**Urgent Field Safety Notice**  
**Voluntary Field Safety Corrective Action**  
**seca 402 und seca 403 Cart for seca Baby Scale**

**Reason for this notice: Instability in the baby scale cart**

## Attachement 1

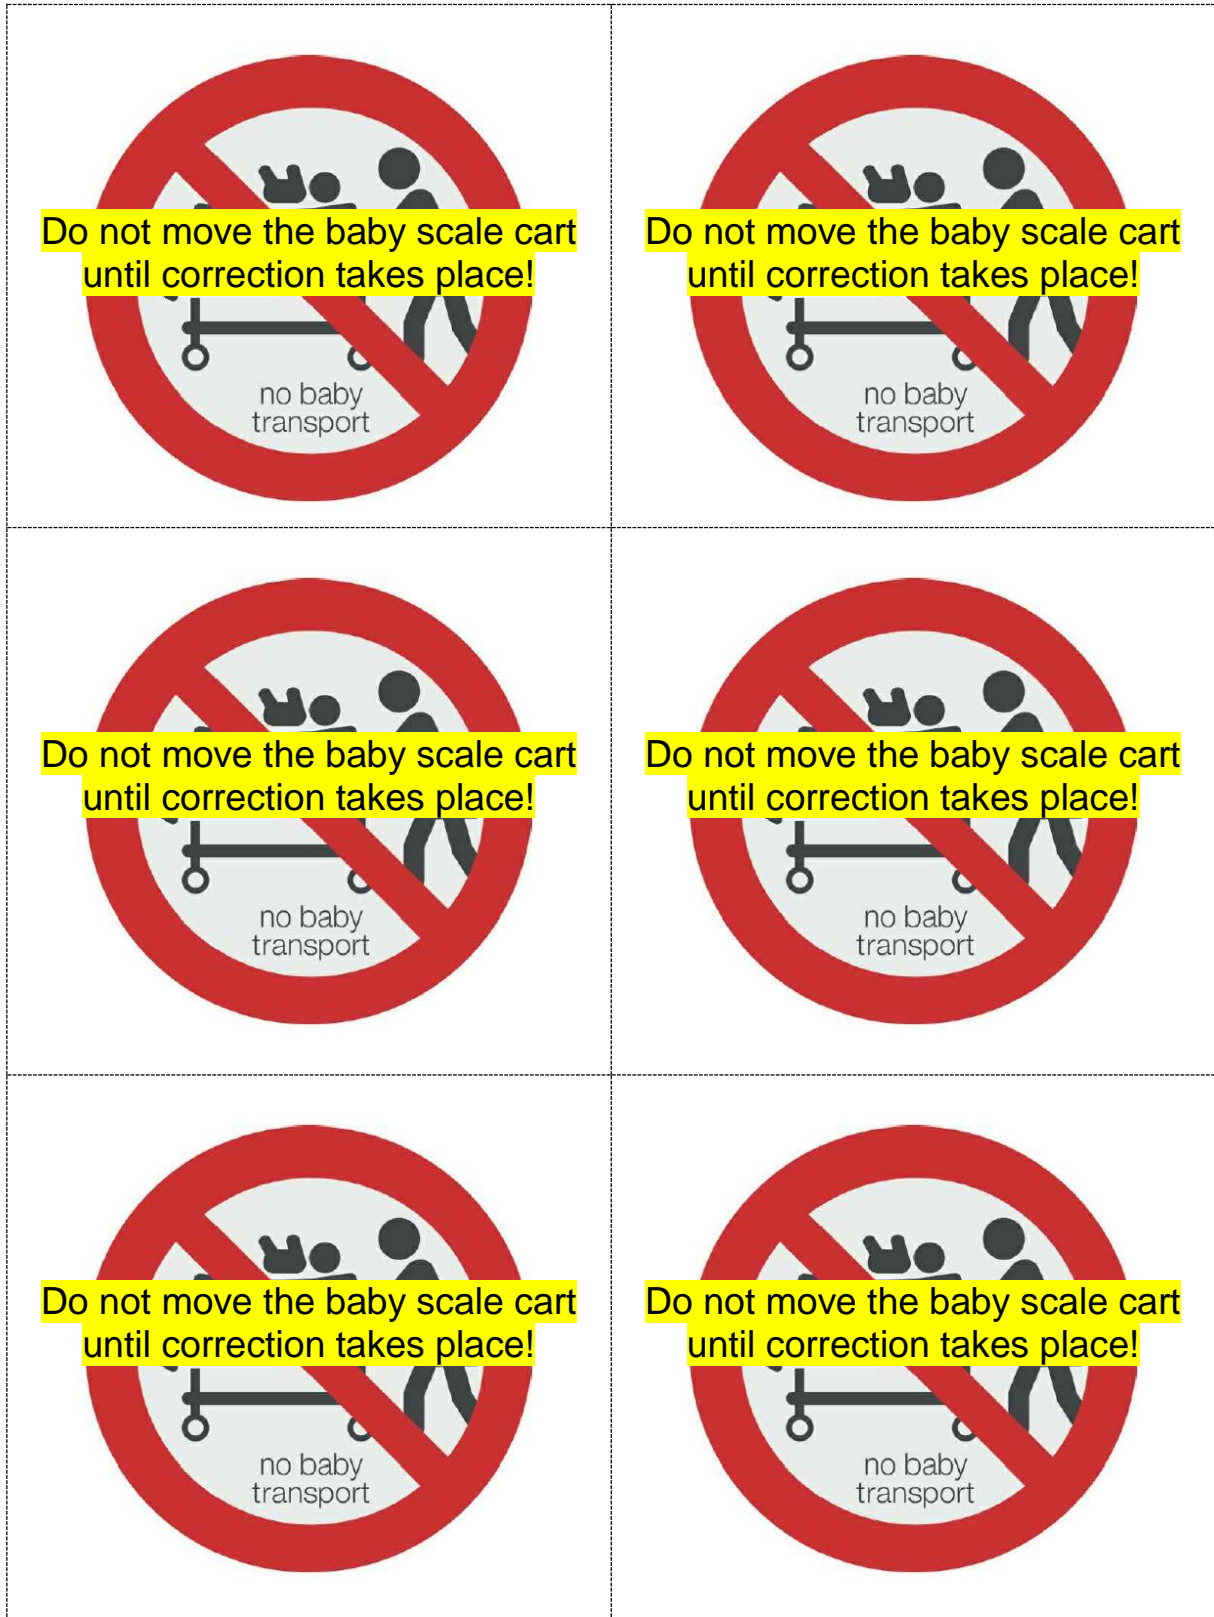
Two wheels of the baby scale cart are equipped with a locking brake that prevents the cart from rolling away and the wheel mountings from rotating on their axes. The screw connections can loosen (see attachment 1) and, in worst case, the wheels can detach from the cart completely. The cart can become unstable and tip over, potentially leading to the scale falling from the cart.

1. With the appropriate hex key (wrench size: 6 mm), re-tighten all the screw connections as firmly as possible (see attachment 1).
2. Apply the brakes on both wheels.
3. Mark the baby scale cart with the warning label (see attachment 2).
4. Do not make mobile use of the cart, use it only at one fixed location.
5. Please confirm receipt of this Urgent Field Safety Notice by returning to us the response form in attachment 3 by e-mail to our local contact person within one week of receipt of this notice.
6. Wait for further information about Upgrade Kit to replace the affected wheels. (see section Upgrade Kits).

seca is already working on a long-term solution in the form of an Upgrade Kit. The kit will consist of two wheels with optimized design and tools for the replacement.
